# Product Change Notice (PCN)

PCN Number: **PCN-0454759R-01**

Product(s) Affected: SJ2-25414D-SMT-TR

PREVIOUS CUI DEVICES DETAIL / IMAGE	NEW CUI DEVICES DETAIL / IMAGE

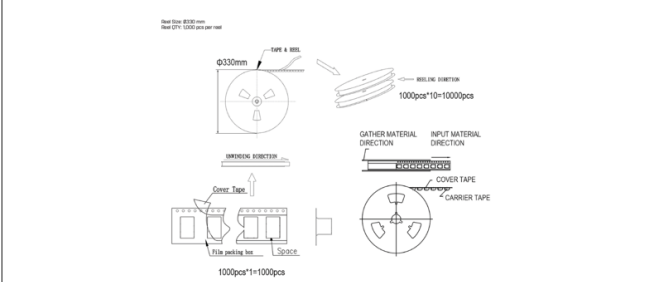
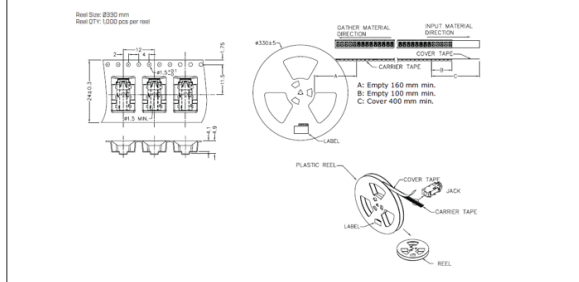
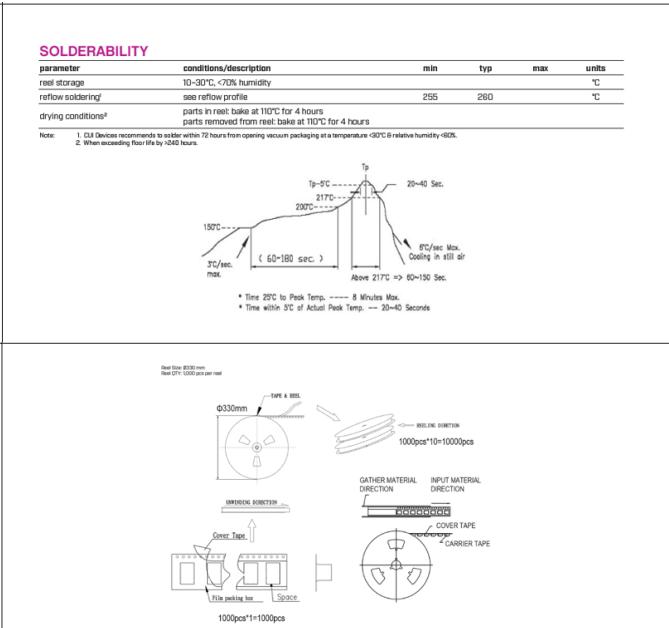
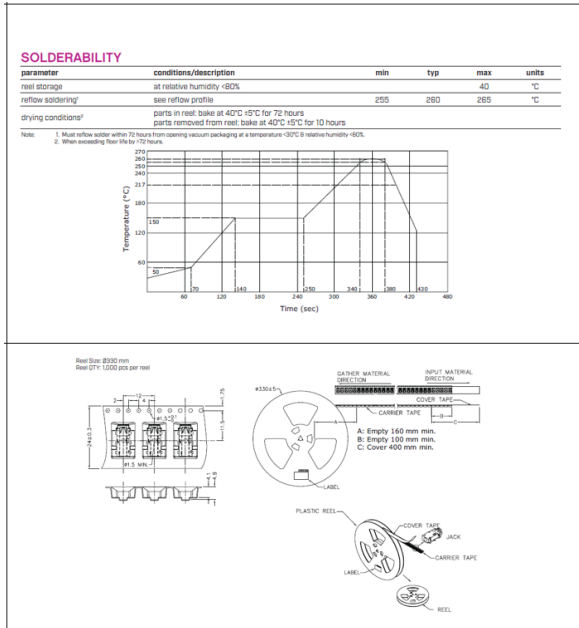
Description of Change: mechanical, material, packaging, and soldering differences as shown below:

<p>Recommended PCB Layout Top View</p>	 <p>Recommended PCB Layout Top View</p>																																																
<table border="1"> <thead> <tr> <th></th> <th>MATERIAL</th> <th>PLATING</th> </tr> </thead> <tbody> <tr> <td>terminal 1</td> <td>copper alloy</td> <td>gold flash</td> </tr> <tr> <td>terminal 2</td> <td>Ti-Cu</td> <td>gold flash</td> </tr> <tr> <td>terminal 3</td> <td>copper alloy</td> <td>gold flash</td> </tr> <tr> <td>terminal 4</td> <td>copper alloy</td> <td>gold flash</td> </tr> <tr> <td>terminal 10</td> <td>brass</td> <td>gold flash</td> </tr> <tr> <td>terminal 11</td> <td>brass</td> <td>gold flash</td> </tr> <tr> <td>plastic</td> <td>PAIOT</td> <td></td> </tr> </tbody> </table>		MATERIAL	PLATING	terminal 1	copper alloy	gold flash	terminal 2	Ti-Cu	gold flash	terminal 3	copper alloy	gold flash	terminal 4	copper alloy	gold flash	terminal 10	brass	gold flash	terminal 11	brass	gold flash	plastic	PAIOT		<table border="1"> <thead> <tr> <th>DESCRIPTION</th> <th>MATERIAL</th> <th>PLATING/COLOR</th> </tr> </thead> <tbody> <tr> <td>terminal 1</td> <td>phosphorus bronze</td> <td>gold</td> </tr> <tr> <td>terminal 2</td> <td>beryllium bronze</td> <td>gold</td> </tr> <tr> <td>terminal 3</td> <td>beryllium bronze</td> <td>gold</td> </tr> <tr> <td>terminal 4</td> <td>beryllium bronze</td> <td>gold</td> </tr> <tr> <td>terminal 10</td> <td>phosphorus bronze</td> <td>gold</td> </tr> <tr> <td>terminal 11</td> <td>phosphorus bronze</td> <td>gold</td> </tr> <tr> <td>housing</td> <td>PPA (UL94V-0)</td> <td>black</td> </tr> </tbody> </table>	DESCRIPTION	MATERIAL	PLATING/COLOR	terminal 1	phosphorus bronze	gold	terminal 2	beryllium bronze	gold	terminal 3	beryllium bronze	gold	terminal 4	beryllium bronze	gold	terminal 10	phosphorus bronze	gold	terminal 11	phosphorus bronze	gold	housing	PPA (UL94V-0)	black

MATERIAL	PLATING																																															
terminal 1	copper alloy	gold flash																																															
terminal 2	Ti-Cu	gold flash																																															
terminal 3	copper alloy	gold flash																																															
terminal 4	copper alloy	gold flash																																															
terminal 10	brass	gold flash																																															
terminal 11	brass	gold flash																																															
plastic	PAIOT																																																
DESCRIPTION	MATERIAL	PLATING/COLOR																																															
terminal 1	phosphorus bronze	gold																																															
terminal 2	beryllium bronze	gold																																															
terminal 3	beryllium bronze	gold

terminal 4	beryllium bronze	gold																																															
terminal 10	phosphorus bronze	gold																																															
terminal 11	phosphorus bronze	gold																																															
housing	PPA (UL94V-0)	black
